January 2024
FL966A-F
NHTSA #23V-073
Transport Canada #2023-051
SECOND REVISED BULLETIN

Subject: Brake Modulator Valves

Models Affected: Specific model years 2017-2022 Freightliner 114SD, and Cascadia; and Western Star 47X, and 49X vehicles manufactured June 28, 2016, through April 8, 2022.

REVISION: The work instruction has been updated to provide clarity of repair and parts needed.

Fig. 1, Modulator Valve

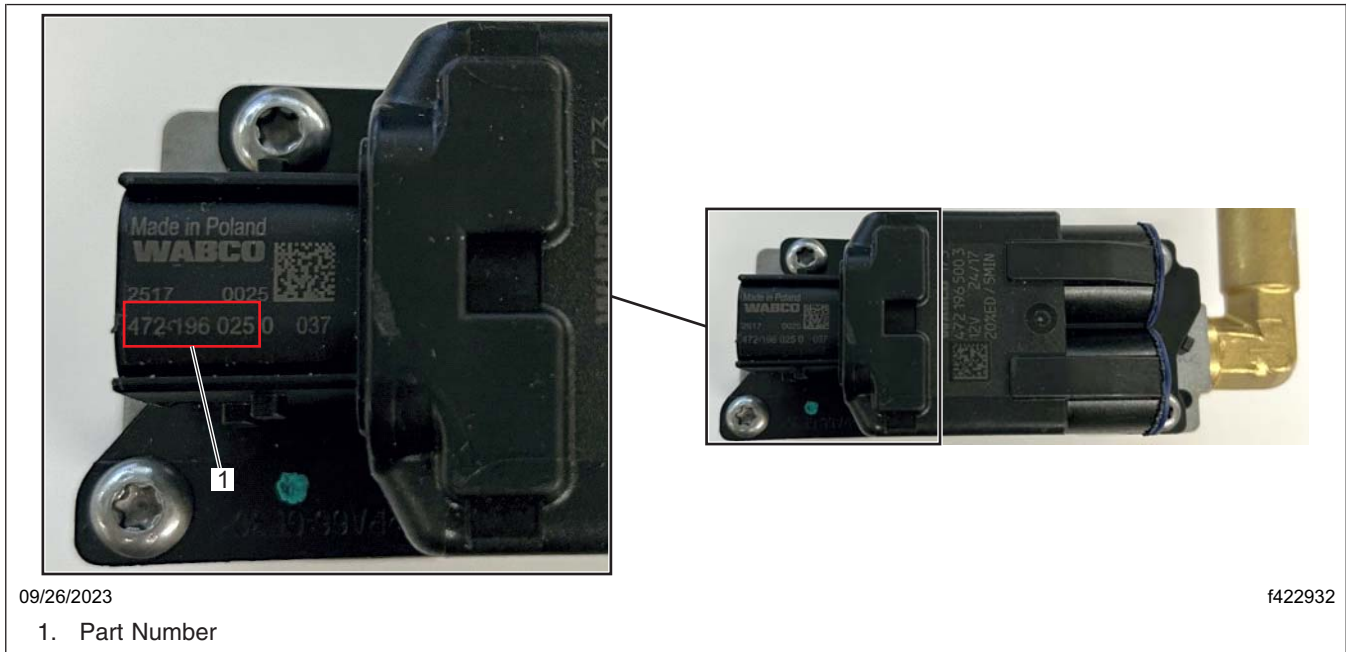
4. Remove the connector from the valve, and inspect the part number underneath the connector. See [Fig. 1](#).

Good part numbers → **472 196 046 0** and **472 196 051 0**

Bad part numbers → **472 196 025 0** and **472 196 037 0**

- If the part numbers are good, install the connector. Clean a spot on the base label (Form WAR259), and attach a campaign completion sticker for FL966 (Form WAR260), indicating this work has been completed.
- If at least one of the part numbers is bad, go to the replacement procedure for the specified group, and replace both the modulator valves.

Fig. 14, Modulator Valve Mounting under the Cross Member

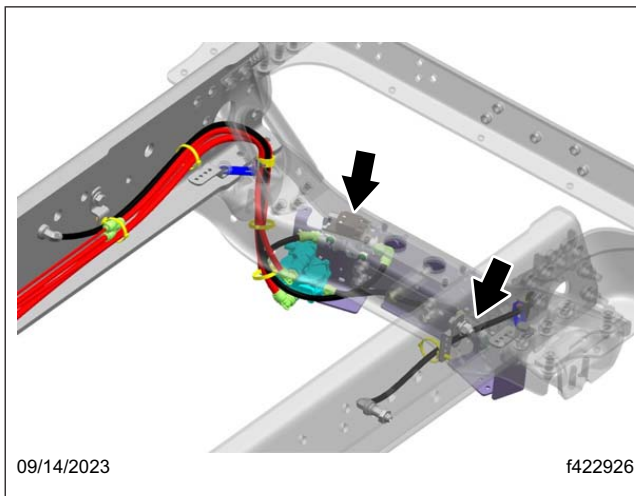
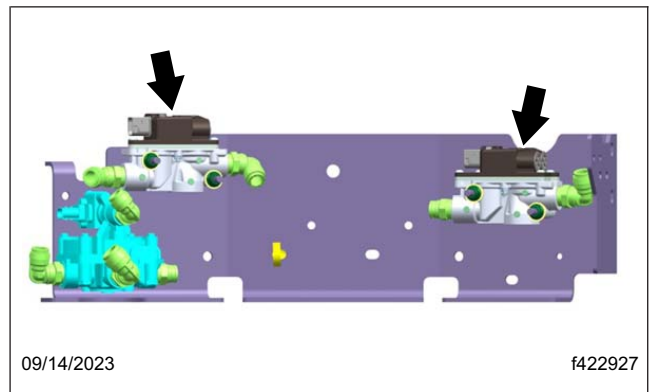
For vehicles belonging to group C, the replacement procedure is the same as groups A and B, but the location of the valves is different. Location of the modulator valve is shown in [Fig. 14](#) and [Fig. 15](#).

Use all of the parts in the recall kit, listed in [Table 4](#), with the exception of the nut (N913023 008003), spacer (23-12240-025), and screw (23-14064-090). Use the nut (23-13861-105, 4 each) from the group C parts list, listed in [Table 4](#).

Fig. 16, Modulator Valve Mounting Inside the Frame Rails

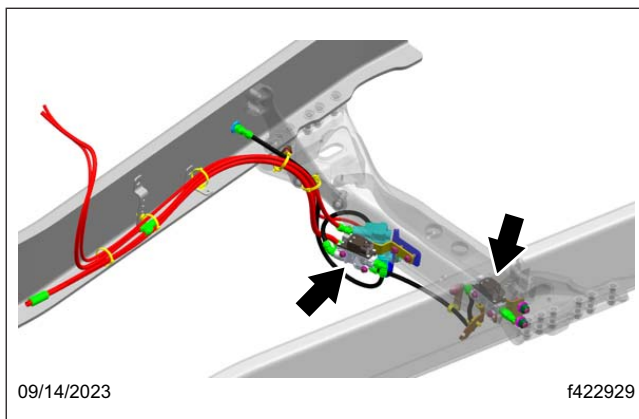
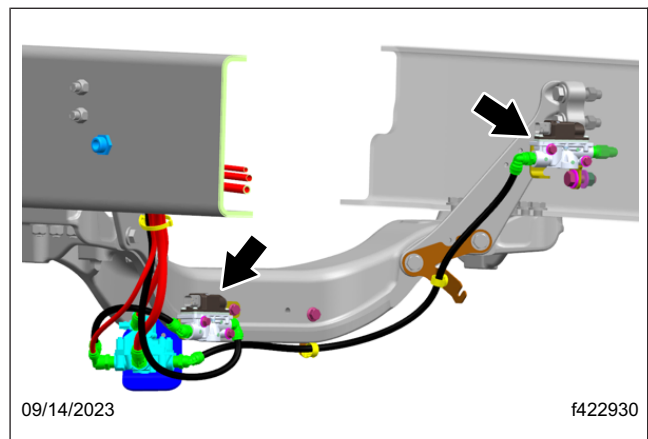
For vehicles belonging to group D, the replacement procedure is the same as groups A and B, but the location of the valves is different. Location of the modulator valve is shown in [Fig. 16](#) and [Fig. 17](#).

Use all of the parts in the recall kit, listed in [Table 5](#), with the exception of the screw (23-14064-090). Use the screw (N910105 008042, 4 each) from the group D parts list, listed in [Table 5](#), instead of the screw in the recall kit. Use only the spacers on the solenoid that is on the engine crossmember and parallel to the engine crossmember. Do not use the spacers on the solenoid that is on the frame rail and perpendicular to the frame rail.

Fig. 18, Modulator Valve Mounting Inside the Frame Rails

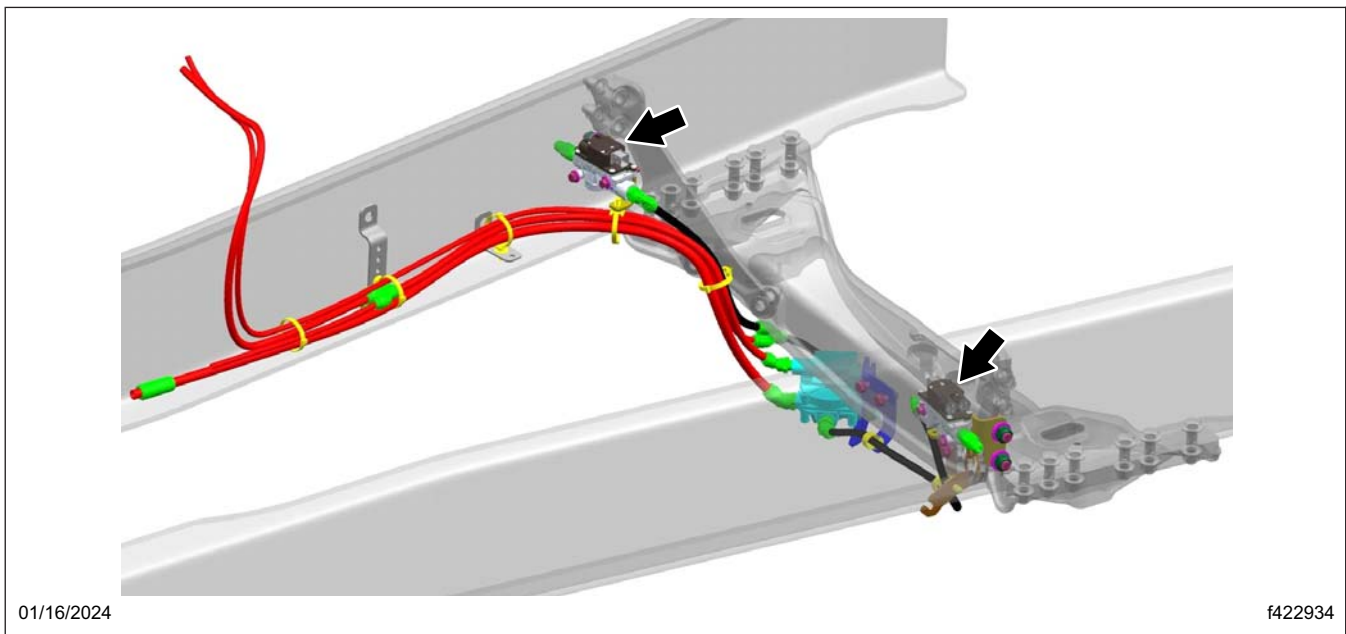
For vehicles belonging to group E, the replacement procedure is the same as groups A and B, but the location of the valves is different. Location of the modulator valve is shown in [Fig. 18](#).

Use all of the parts in the recall kit, listed in [Table 6](#), with the exception of the screw (23-14064-090), and spacer (23-12240-025). Use the screw (N910105 008042, 4 each) from the group E parts list, listed in [Table 6](#).

Fig. 19, Modulator Valve Mounting Inside the Frame Rails

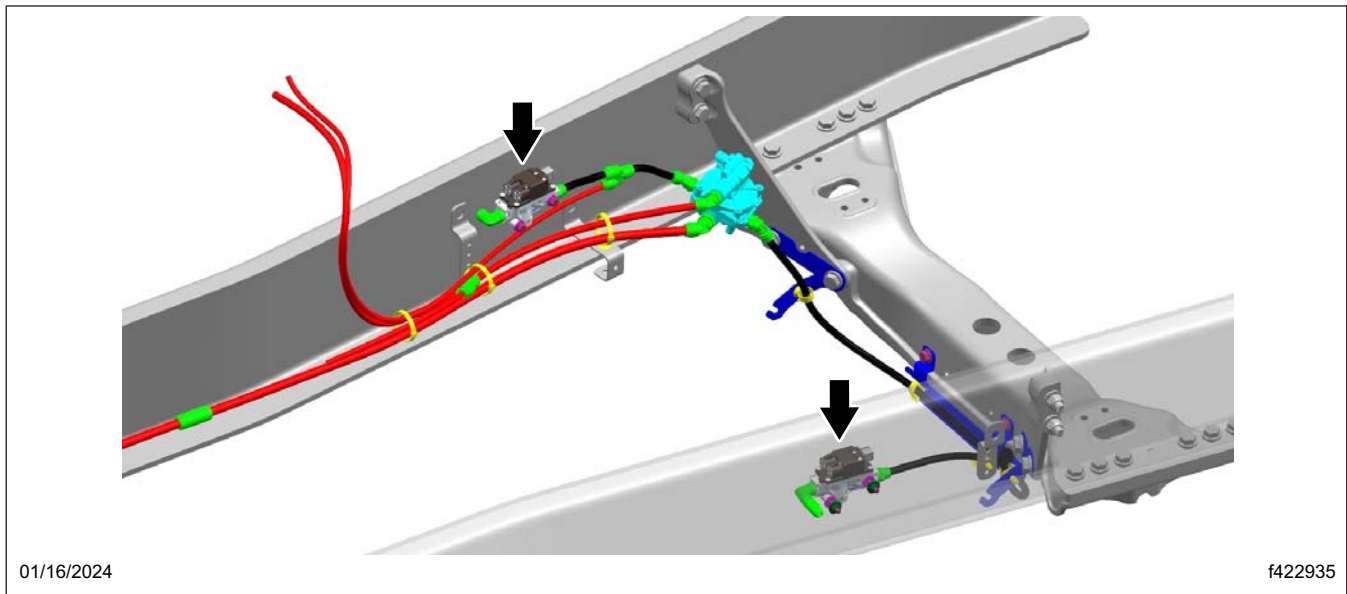
For vehicles belonging to group F, the replacement procedure is the same as groups A and B, but the location of the valves is different. Location of the modulator valve is shown in [Fig. 19](#).

Use only the solenoid (25-FL958-001), and washer (23-09114-002) from the recall kit, listed in [Table 7](#). Use the spacer (23-11427-075, 4 each), screw (23-12489-095, 4 each), and nut (23-14525-000, 4 each) from the group F parts list, listed in [Table 7](#).
